**Seventy-fifth session**

**Light vehicles – Global Technical**

**Proposal for Amendment 3 to global technical regulation  
No. 15 (Worldwide harmonized Light vehicles Test  
Procedures (WLTP))**

**Submitted by the Informal Working Group on Worldwide harmonized  
Light vehicles Test Procedure (WLTP)\***

Figure A2/1b

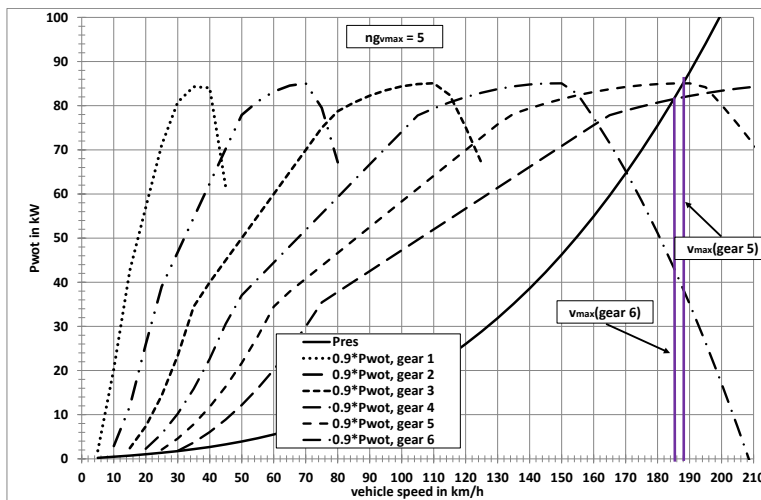
$v_{max}(ng-1)$  is the vehicle speed at which the required road load power equals the available power  $P_{wot}$  in the next lower gear (gear  $ng-1$ ). ~~(See Figure A2/1b).~~
